C S Stokes and Associates Limited

18th March 2014

Premises: Grenfell Tower, Testerton, Barandon and Hurstway Walks on the Lancaster West Estate

Thank you for asking me to comment on the questions raised by the London Fire Brigade (LFB) officers during they visit to the above buildings on the Lancaster West estate on the 12th March. The LFB fire officers were Ben Lewis, Mathew Ramsey and Dan Hussey and you were accompanied by Mr Bruce Sounes of STUDIO E, the questions asked were contained in your e mails to me from notes that were taken during the visit. I visited the above premises yesterday, Monday the 17th March 2014 to gather the information for this report, the information on service dates etc was obtained from the contractors servicing and maintenance logbooks held on site and from records from the TMO's engineers section at the Hub.

Refuse chute room extraction control panel on the left with the flat/lift lobby areas control panel on the right hand side.

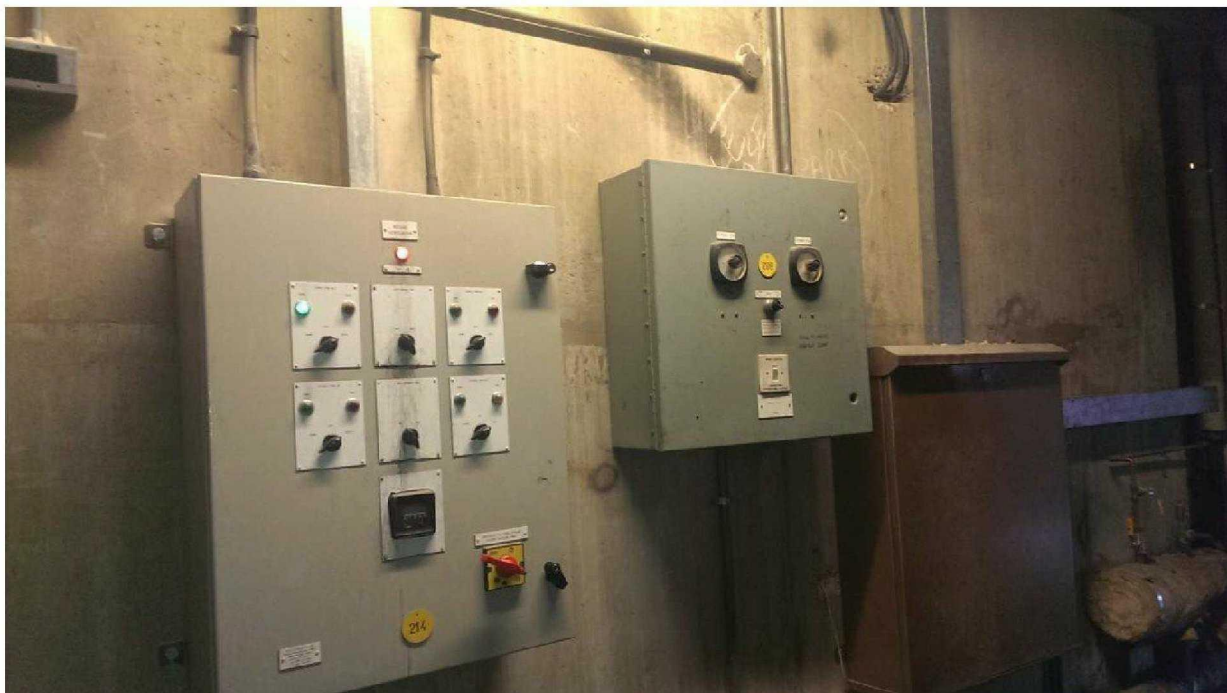
There is a mechanical ventilation extraction system located on the flat/lift lobby areas of Grenfell Tower, there are two vents each side of the flat/lift lobby area with the extraction plant and control panels etc located in the roof level extraction plant room. As well as there being mechanical extraction in the flat/lift lobby areas there is also mechanical extraction in the refuse chute rooms. Please see the first photograph below showing the different control panels for the plant the refuse chute room extraction control panel is on the left with the flat/lift lobby areas emergency smoke control extract panel on the right hand side of it. There is also an extraction system for the mechanical extractors located in the toilets, this control panel for this is located on the opposite wall, plant and duct work etc for these extract systems are also located in this roof level plant room area.

The emergency smoke control extract panel was showing healthy when looked at yesterday with the switch in the auto position. The flat/lift lobby extraction system is activated by the automatic fire detection device on each of the flat/lift lobby area ceilings. The extraction system works by the vents on one side of the flat/lift lobby area expelling the smoke with inflow air coming in through the vents on the other side of the lobby area.

This smoke extraction system is on a planned preventive maintenance programme with RGE, this contractor last serviced this system according to their on site log book on the 15/15/13 *sic*. Please see appendix A below, the previous loose page in the logbook was full and the service before this one was in September 2013 so I am assuming that the 15th month is a mistake and the engineer meant the 12th Month. As can be seen the engineer checked all of the items in the quarterly check list and the only fault recorded was 19th floor relay.

As the next quarterly service is imminently due on this smoke extraction system I would recommend the contractor is asked to service the system and any findings etc made are actioned.

1. The next quarterly service is imminently due on the emergency smoke extraction system installed on the flat/lift lobby areas of Grenfell Tower, the last service by the contractor stated that the system was in working order apart from one reply. I would recommend the contractor is asked to service the system sooner rather than later and any findings etc made by him are actioned upon. If this system is in working order there is no requirement to a CFD analysis to be undertaken.

Dry rising main

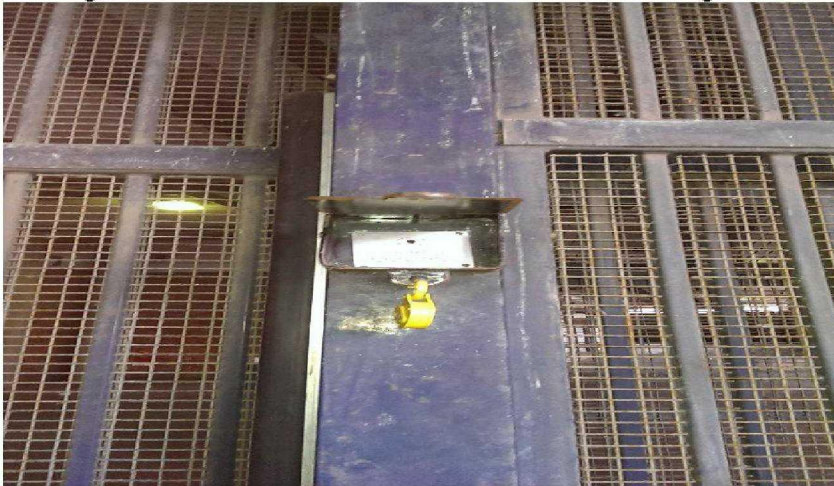
There are dry rising mains installed in these figure blocks, the inlet is located at the lower ground floor level, in the areas underneath the residential areas with the outlets being located directly above the inlets. Each riser is numbered with black paint on the front of the dry riser box, so number 6 dry riser inlet feeds number 6 dry riser outlet which is located directly above it. The dry risers in Testerton and Hurstway Walks were last tested by M and P Fire Protection Limited on the 30th December 2013 according to the contractors label fixed inside these inlet and outlet boxes. Please see the recommendation reference Barandon Walk. Located above the dry riser inlets there is another red painted box this contains an outlet from a ring main, this is different from a town main which is the normal way for water to be provided. As far as I am aware this ring main was installed when the premises was constructed, it could have been considered that a wall mounted water ring main would be easier to maintain than an under ground hydrant one. A ring main is a recognised way of providing water to inaccessible places it also has the advantage that the fire service do not need to use a standpipe key and bar etc when connecting to it. In this case this is a water filled pipe above ground rather than underground which is maintained serviceable by the TMO, the last test was undertaken by M and P Fire Protection Limited on the 29th November 2013 according to the contractors label fixed inside the ring main boxes. The water pressure at the time of this last test was 4.4 bar.

How this system is used by the fire service is a matter for them to decided, also it is up to them to decide if they drive fire appliances into the lower ground floor level roads to apply pressure to the system so that they have a fire fight jet on the upper floor levels. There have been different padlocks fitted to the ring main boxes that the normal FB padlocks, the currently fitted padlocks should be removed and the standard FB padlocks fitted so that the LFB can open the boxes easily.

9. There have been different padlocks fitted to the ring main boxes that the normal FB padlocks, the currently fitted padlocks should be removed and the standard FB padlocks fitted to each ring main box so that the LFB can open the boxes easily.

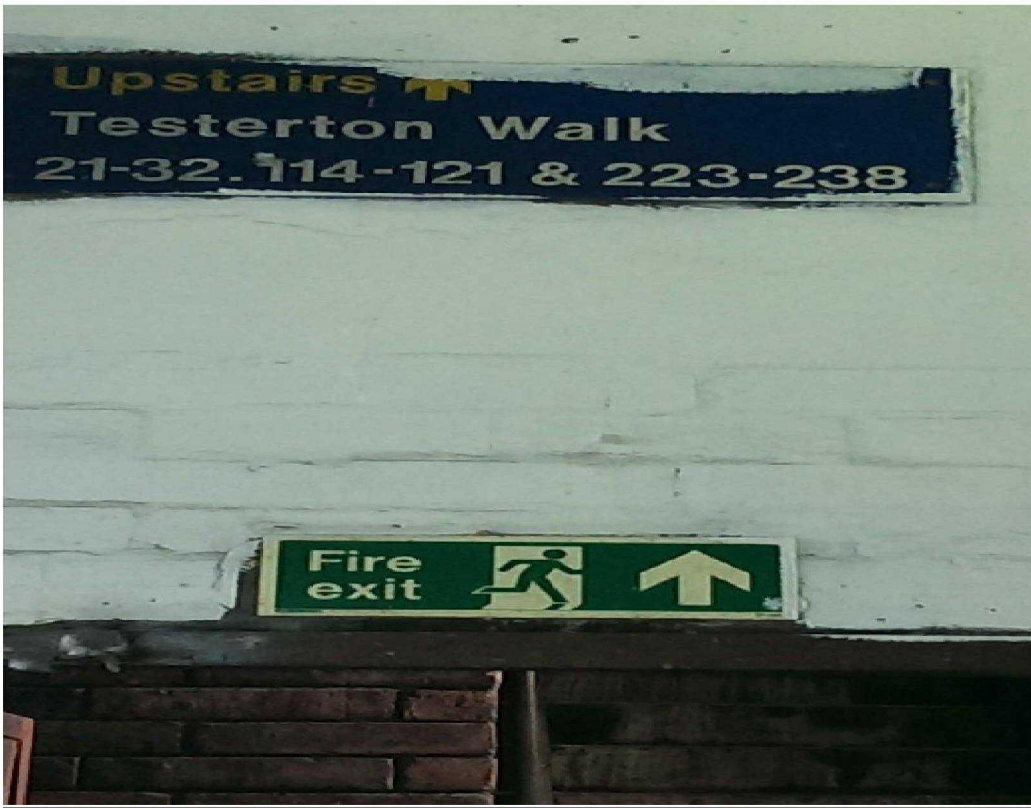
The fire officers commented on the storage of flammable materials in the OCS cleaners store of Hurstway Road. This is a garage area where cars can be parked and garaged with upwards of 100 litres of petrol in their fuel tanks, this garage area was designed to

have cars parked in it containing flammable liquid. When I looked in the OCS storage area yesterday there were two 5 litre purpose made green plastic petrol containers stored here. This petrol is used for the leave blowers, I do not believe that any further action is needed on this issue.
